**FINAL**  
**ADDENDUM #1 TO THE 2003 LONG RANGE DEVELOPMENT PLAN**  
**ENVIRONMENTAL IMPACT REPORT**  
(State Clearinghouse No. 2002102092)  
November 2006

**I. INTRODUCTION**

To accommodate the changes to the NMP described above, the 2003 LRDP land use diagram has been revised. Figure 1 shows the 2003 LRDP land use designation for the NMP area as previously approved. Figure 2 shows the revised 2003 LRDP land use designations for the same area.

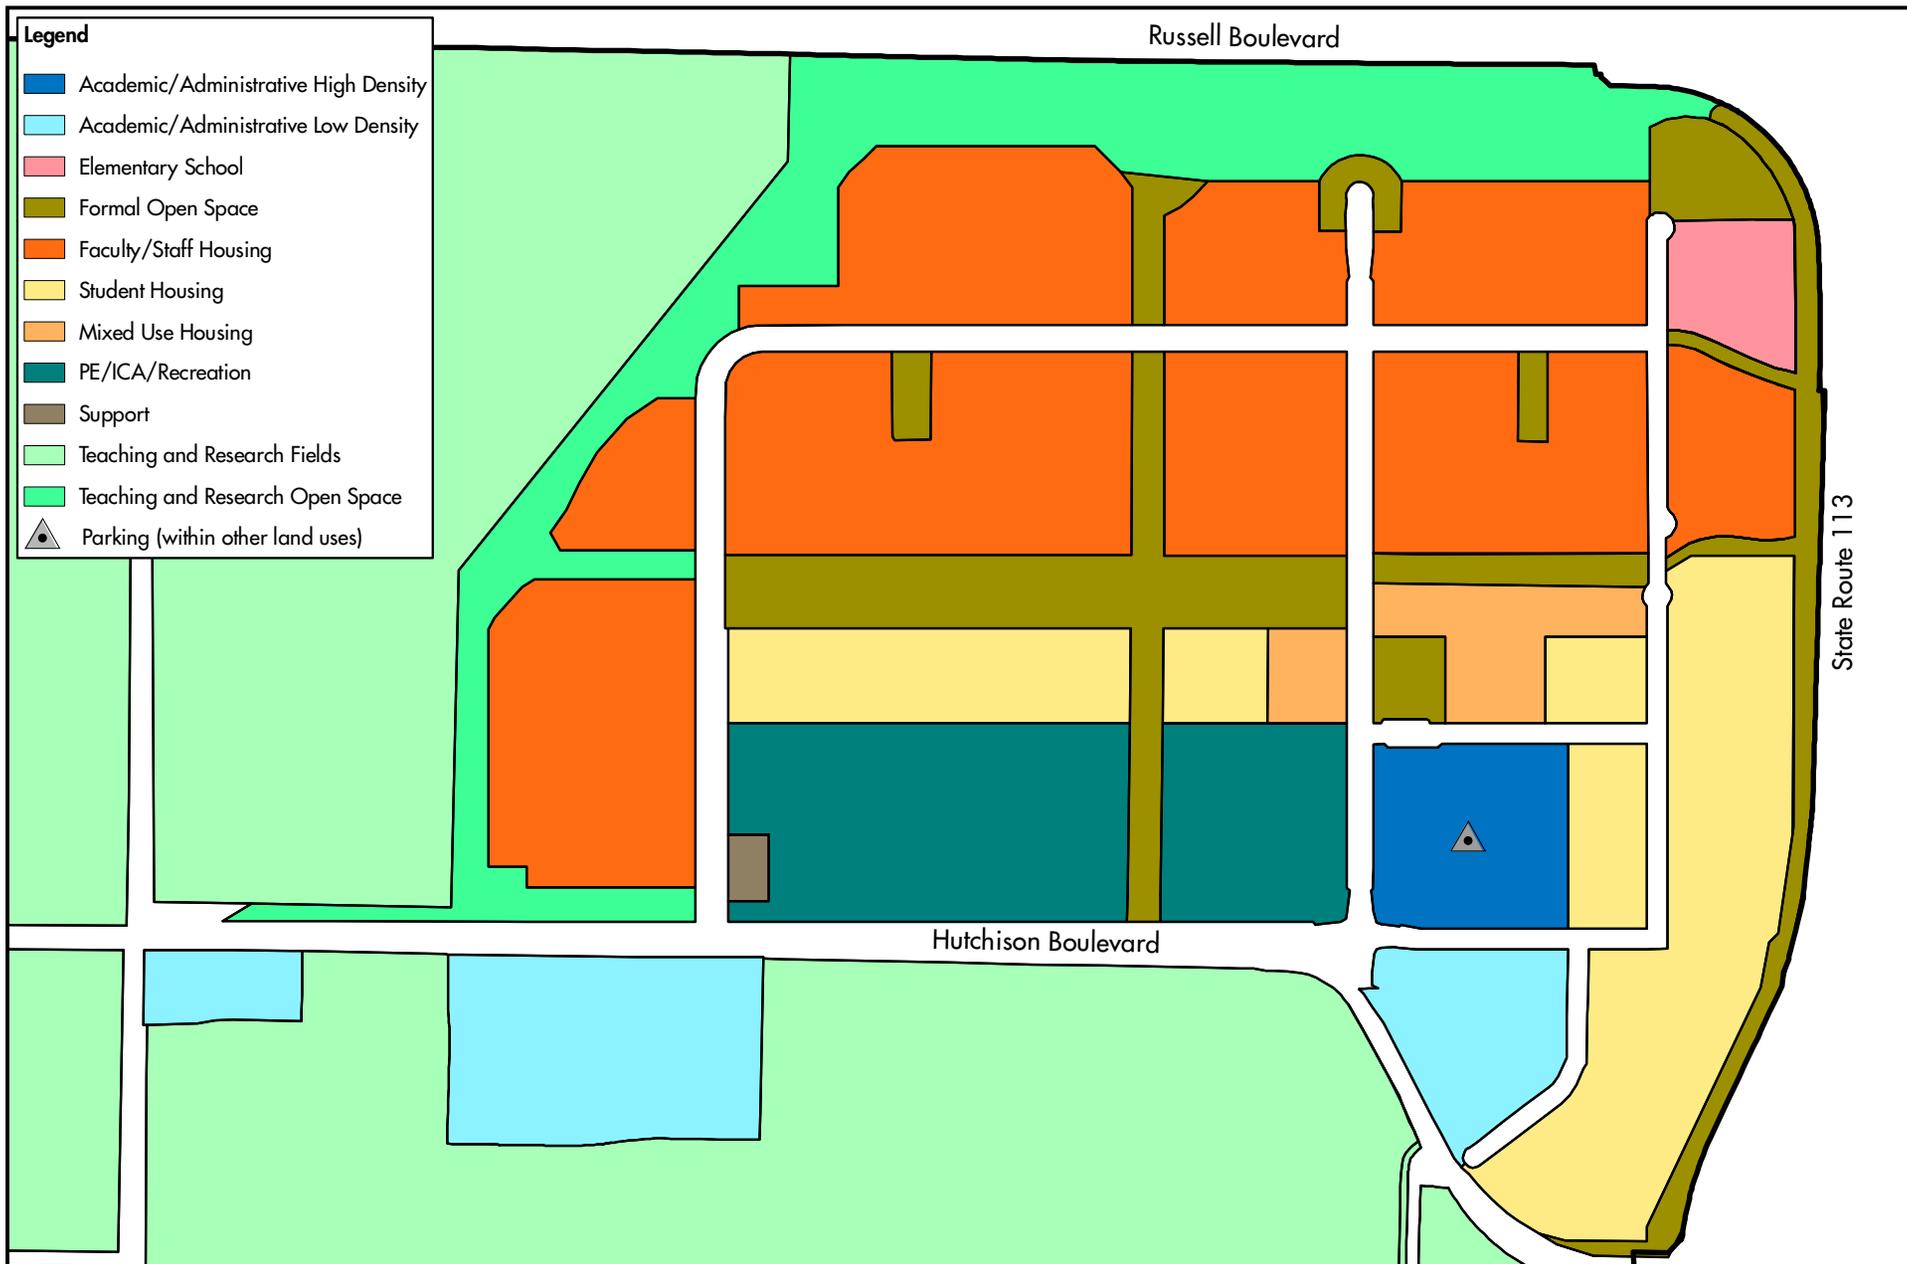
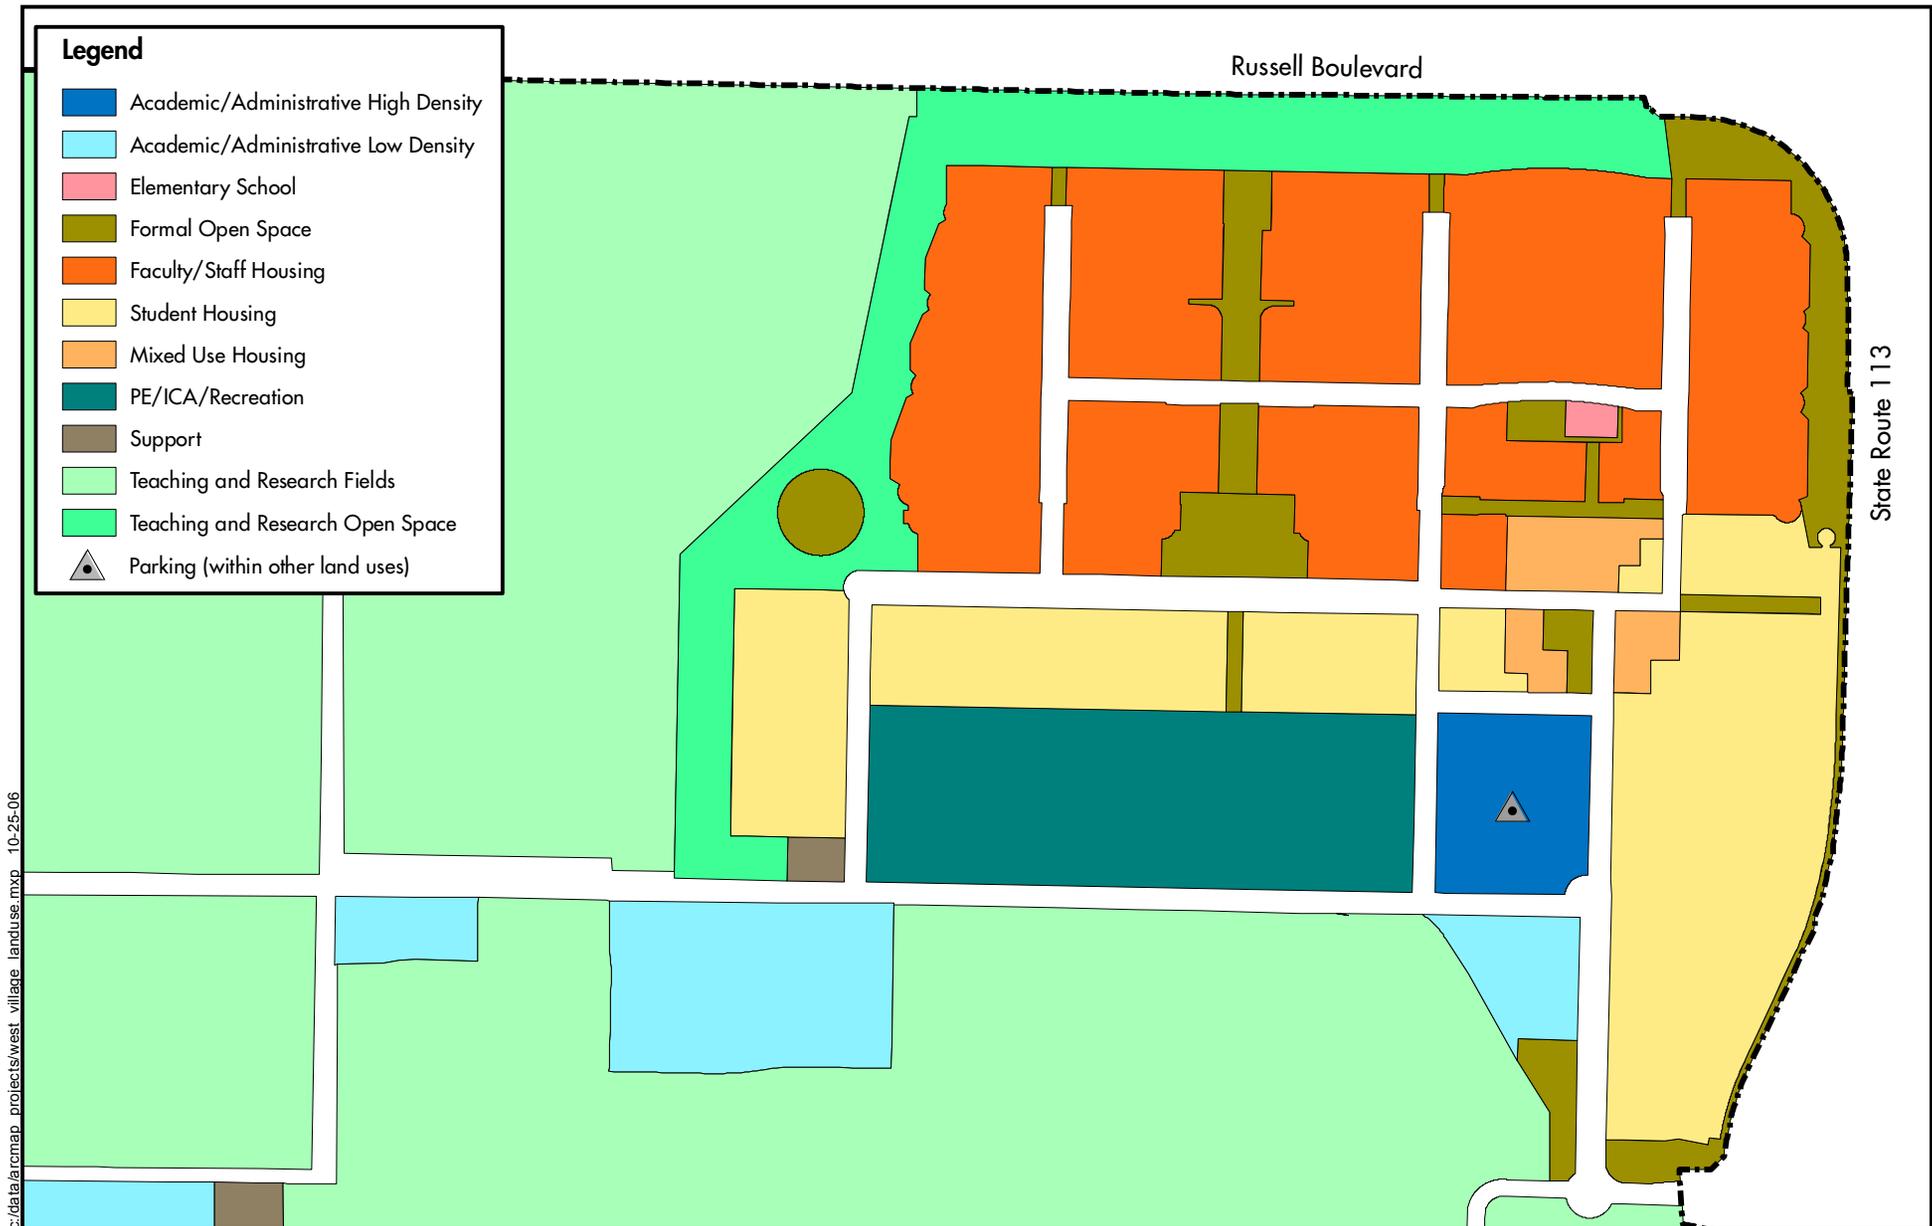
Although the major elements of the approved NMP remain unchanged (Figure 2), the NMP is revised in the following respects as a result of further refinement during the process of preparing the WVIP.

- The total area of the West Village is reduced from approximately 225 acres as identified in the 2003 LRDP Final EIR to approximately 208 acres in the WVIP. The source of this reduction is the realignment of the Hutchison Drive entry roadway of the West Village (described in more detail below), a more compact development pattern which contracts the western boundary of West Village, and the exclusion of the Western Center for Agricultural Equipment (WCAE) from the West Village site.

- Hutchison Drive is proposed to be realigned to the east of the WCAE, rather than to the west. A roundabout would be constructed at least 500 feet west of SR-113 southbound ramp intersection, and Campbell Road would form the west leg of the proposed roundabout intersection. This change allows the existing section of Hutchison Drive west of the WCAE to be removed, creating a direct connection from the WCAE to agricultural fields on the west. This change also allows Phase 1 of the WVIP to expand and include the Phase 3 area of the NMP, thereby reducing the number of phases to two. Consolidating the number of phases would not affect the rate or timing of overall construction because: (1) the total number of units will not exceed the number approved in the NMP; (2) market conditions are expected to determine the actual pace of development (page 2-49, Volume III of the LRDP EIR); and (3) subsequent phases were always anticipated to start before earlier phases were completed (page 2-49, Volume III of the LRDP EIR). Realigning the entrance road improves connectivity of the West Village to the central campus and provides more student housing in Phase 1 of the WVIP. With this change, the West Village would be built in two phases instead of three phases as described in the LRDP Final EIR.

- The elementary school site has been relocated approximately 700 feet to the west of its previous location and is anticipated to be used for either an elementary school, a pre-school facility or a child day care facility. This expands the setback between the site and SR-113. This relocation also places the site more central to faculty and staff housing. In addition, the acreage for the site has been reduced. The potential uses on the site have been broadened so that the site can be used for child-related facilities other than an elementary school in the likely event that the Davis Joint Unified School District decides that an elementary school is not needed.<sup>1</sup>

- The village square has been shifted one block to the east of its location in the NMP to accommodate the change in the alignment of the main entry roadway. The locations of uses around the village square also have shifted slightly.

**Figure 3**  
**U.C. DAVIS WEST VILLAGE**  
**PROPOSED BACKBONE INFRASTRUCTURE**  
**MAY 2006**

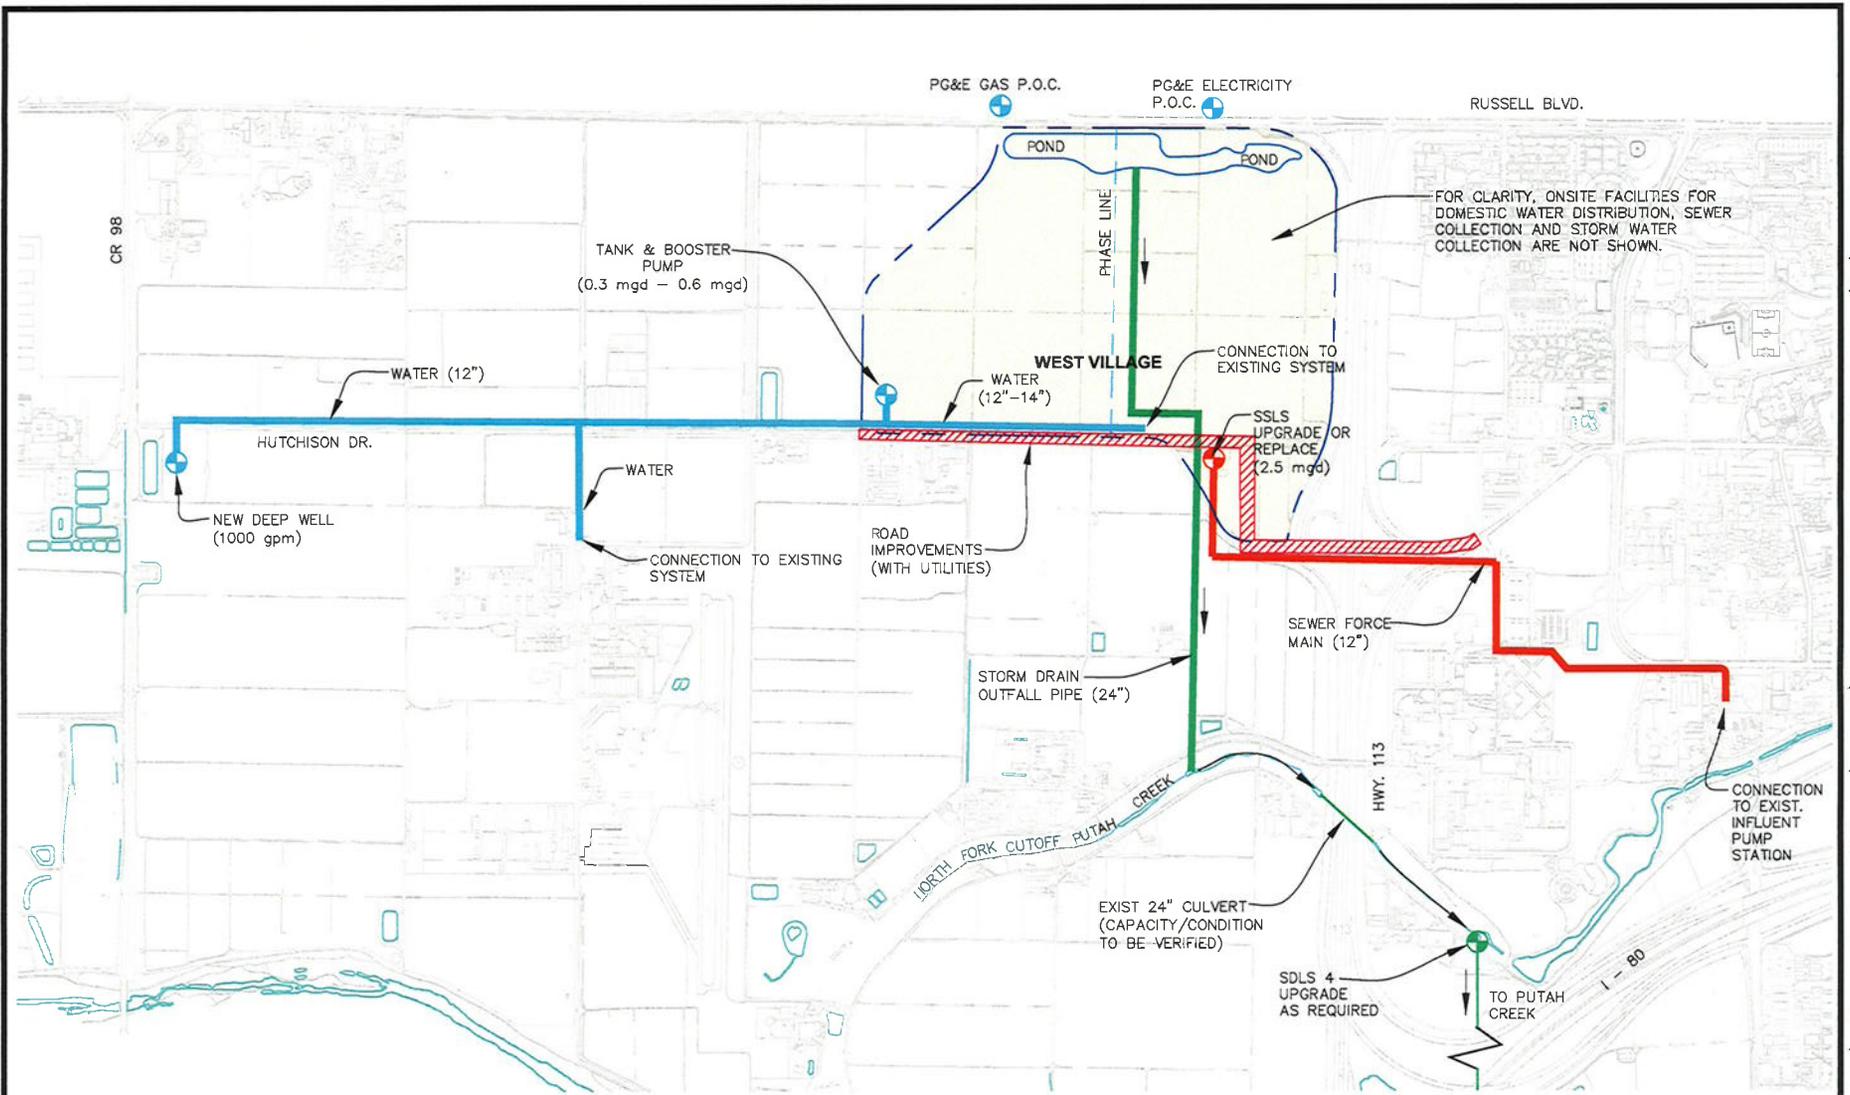
Because the total population of the West Village would not be greater than the population previously evaluated in the 2003 LRDP Final EIR, the projected peak demand and annual consumption of utilities would not increase over levels reported in the 2003 LRDP Final EIR. For some utilities, the NMP identified and evaluated more than one option. The selected option and some proposed minor changes to the manner in which some of the utilities would be provided to the site (Figure 3) are described below.

- **Domestic Water:** The 2003 LRDP Final EIR discussed and evaluated three options for supplying domestic water to the neighborhood. The WVIP incorporates two of the options evaluated in the 2003 LRDP EIR: (1) a new well located on or near the neighborhood that connects to the campus system and (2) a new tank on or near the neighborhood that connects to the campus system. The 2003 LRDP EIR assumed that the one or the other of these options would be used and that, if located off-site, would be approximately ½ mile west of the neighborhood. The WVIP incorporates both. The new well would be located further west on the south of Hutchison Drive just east of County Road 98, approximately ½ mile further west than in described in the 2003 LRDP EIR. The new tank would be located within the boundaries of the neighborhood. Therefore, the total area outside the neighborhood boundary that would be disturbed remains approximately ½ acre as described in the 2003 LRDP EIR. In addition, the existing water line in Hutchison Drive would be replaced with a larger main to serve the West Village and future 2003 LRDP needs on the west campus.

- **Storm Water:** Similar to the previously evaluated plan, site storm water would be collected in the ponds south of Russell Boulevard. However, south of the West Village, it would be conveyed by a new storm drain that would be aligned along Campbell Road as opposed to the previously proposed alignment along SR-113. The storm drain would have an outfall on the North Fork Cutoff west of SR-113 and not on Putah Creek as previously considered. From the North Fork Cutoff, storm water would be discharged via the existing siphon under SR-113 to the Arboretum pump pond.

- **Wastewater:** Wastewater would be conveyed to the central campus by a new force main aligned along Hutchison Drive and other central campus streets up to the existing influent pump station on La Rue Road, which is consistent with the 2003 LRDP EIR.
